Reiche School Phase 3

Site Improvements

TO: Barbara Barhydt
FROM: Dan Goyette, PE, and Lauren Swett, EIT
DATE: April 6, 2007
RE: Reiche Community School, Phase III Site Improvements

Minor Site Plan Review Comments

FIGURE I-11 BRICK DRIVEWAY ON BITUMINOUS BASE

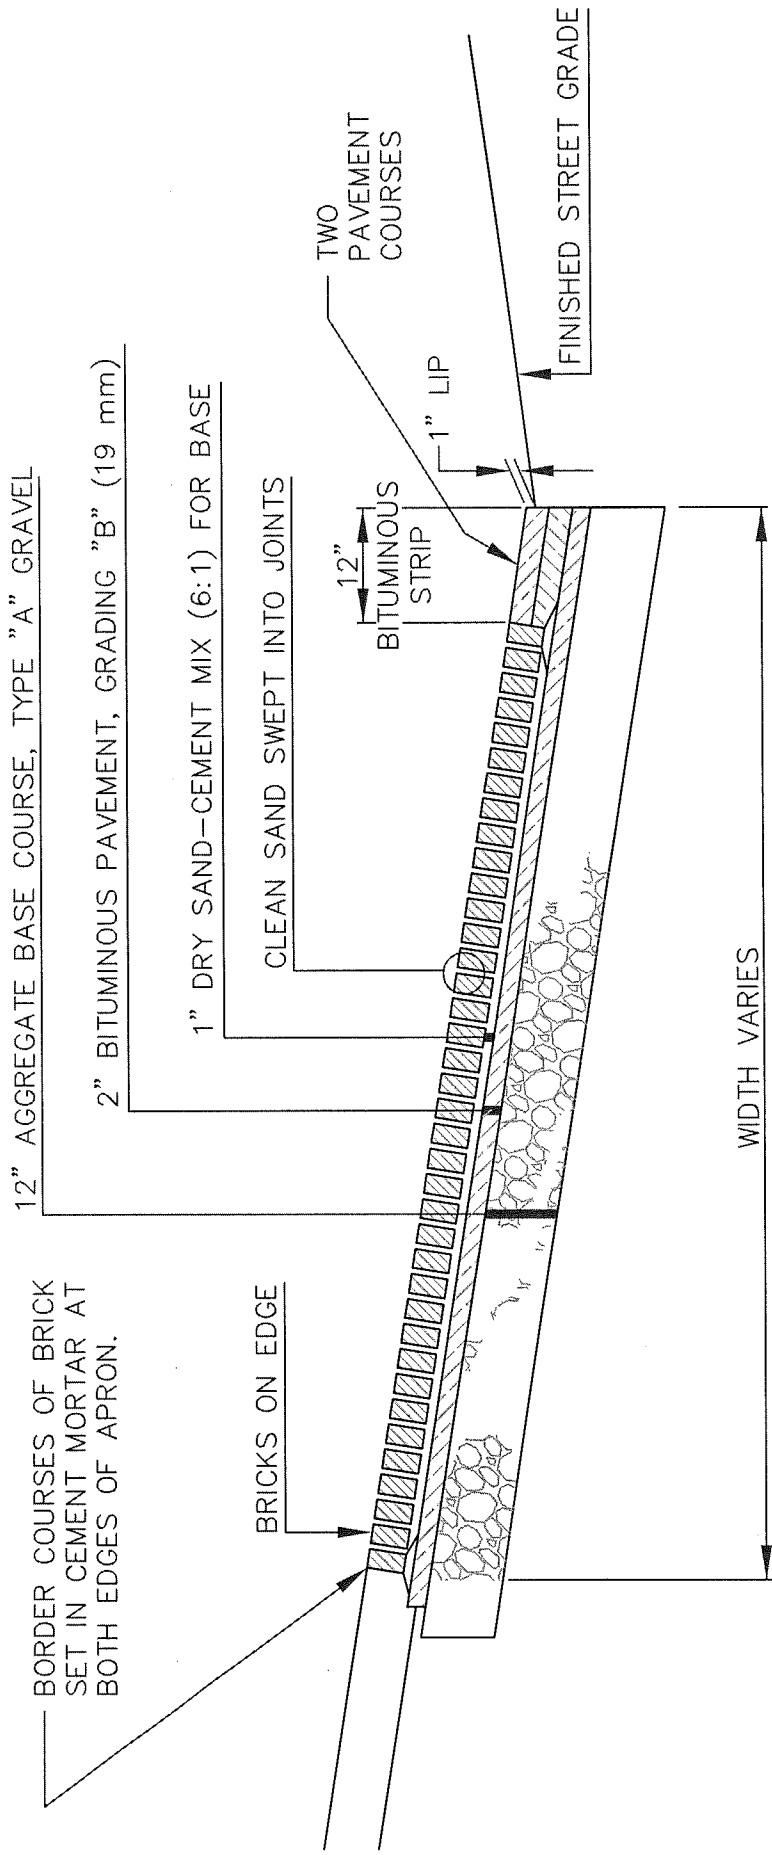
I have attached our design details for brick sidewalks and brick driveway aprons. The appropriate details should be used in the project plans, instead of the details in the plans submitted for review.

We have revised the brick sidewalk (detail 9) and brick driveway apron (detail 5) on Sheet 3 to meet the details Mike Farmer provided.

METAL BOLLARD

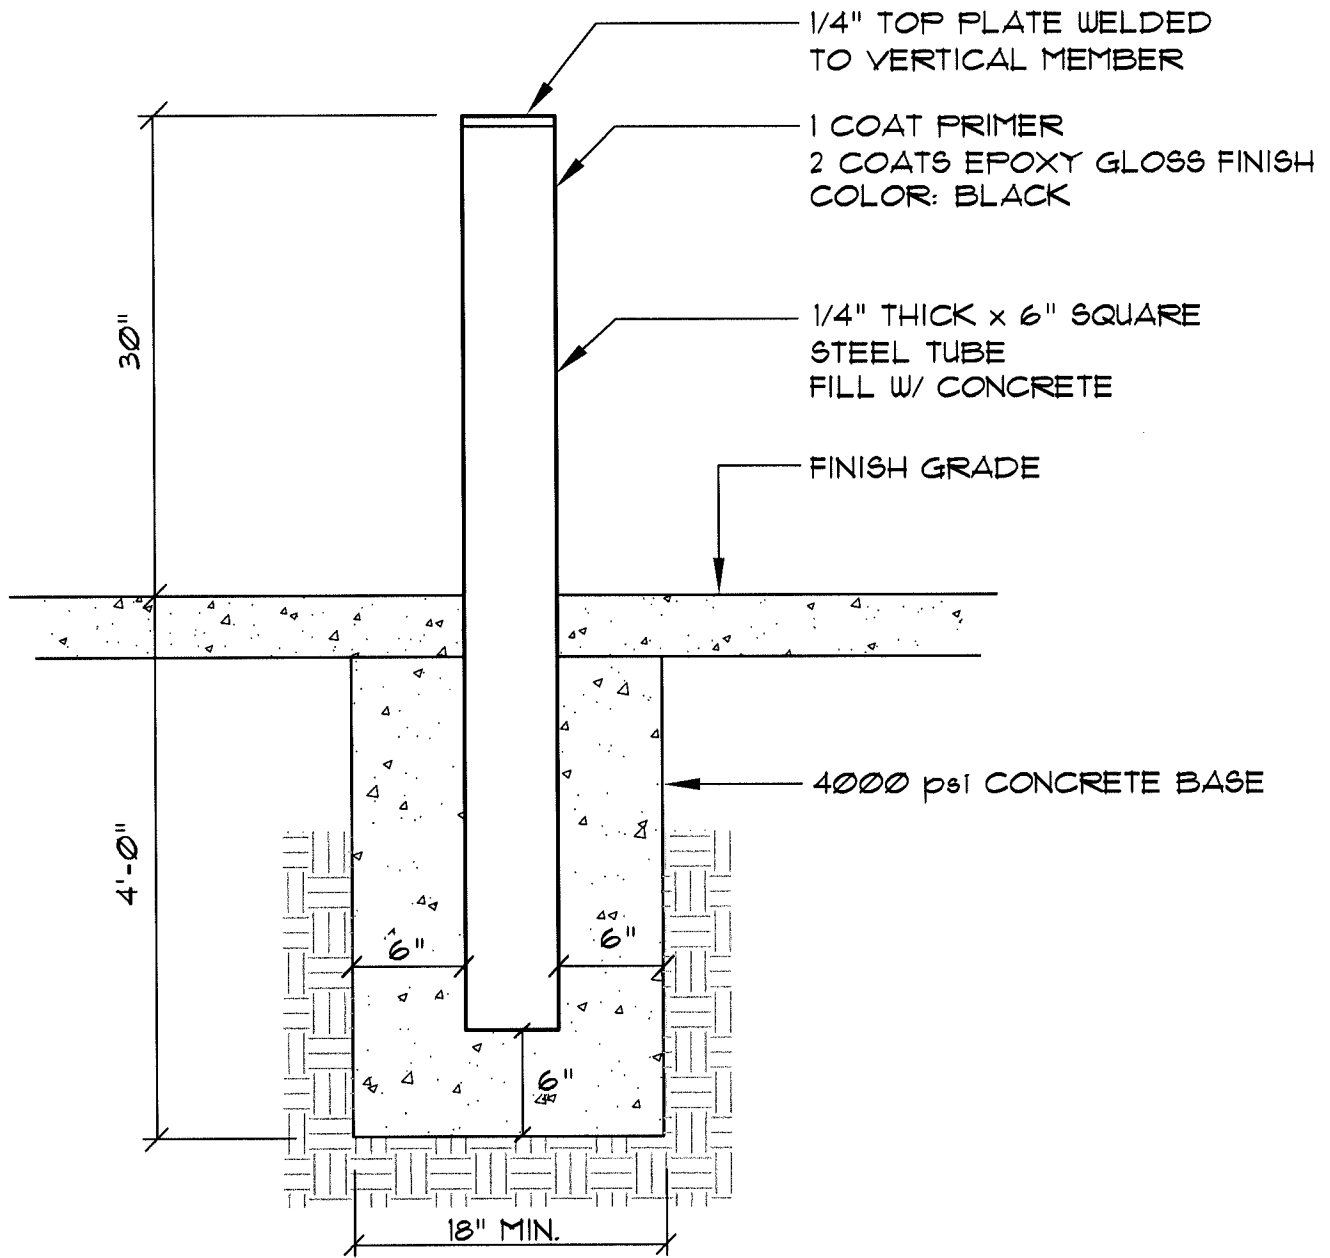
Boulders at the rear of the Clark Street parking lot are not appropriate in an historic district. Would prefer to have a simple line of pressure treated 8" x 8" posts, either with tops cut at an angle or with a 2 x 8 plant guardrail connecting them.

We have removed the proposed boulders from the plan and have submitted for maintenance reasons a simple metal bollard painted black spaced approximately 7 to 8 feet apart (see attached detail).
